Product Change Notification

108781 - 01

Change Notification #: 108781 - 01
Change Title: Intel(R) IP Network Server NSC2U, PCN 108781-01, Product Material, Cable shield removal, Reason for Revision: Canceling this change
Date of Publication: February 18, 2009

Old design with shield to protect the baseboard power cables.

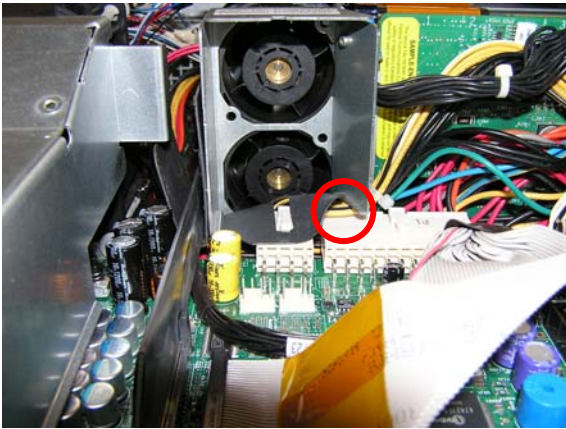
Intel has removed the cable shield that protected the baseboard power cables. The shield was located under the 40 mm fan set.

Original design required the shield because the metal fan shroud was in contact with the cables.

Plastic fan shroud design provides more relief for power cables. Revised system design has shield removed.

Reason for Revision: Canceling this change

This change is canceled because there is no technical requirement to remove the cable shield. This reduces the number of changes to the product. Customers should continue to integrate and use the product as normal.
